MIL-C-19978/5A
AMENDMENT 3
29 November 1994
SUPERSEDING
AMENDMENT 2
20 July 1984

MILITARY SPECIFICATION SHEET

CAPACITORS, FIXED, PLASTIC DIELECTRIC,
(HERMETICALLY SEALED IN METAL CASES),
STYLES CQ06 AND CQ07

STYLE CQ06 (uninsulated case) STYLE CQ07 (insulated case)

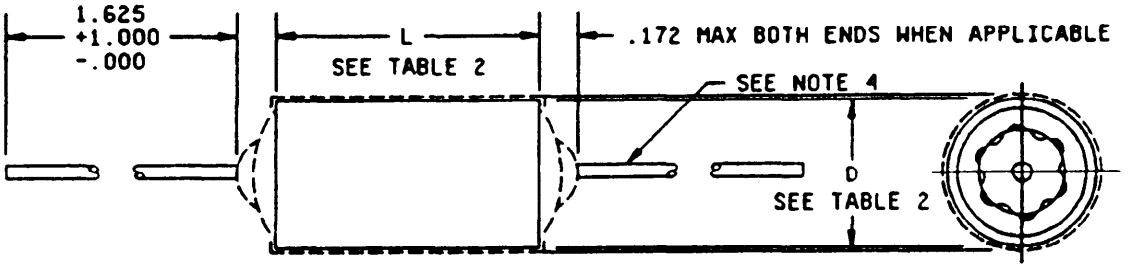
* FIGURE 1, Style CQ06 (uninsulated case) and style CQ07 (insulated case), delete and substitute:

NOTE 5, delete and substitute:

"5. Capacitors with dimension L of 1.562 or D of .562 and larger, are not intended to be supported by their leads. These capacitors shall be supported with a supplementary means of mounting, such as tangential retainer for styles CQ06, and a wrap-around band for style CQ07. The supporting device will not be supplied with the capacitor.
6. Lead length may be a minimum of 1-inch long for use in tape and reel packaging when specified in the ordering data. "
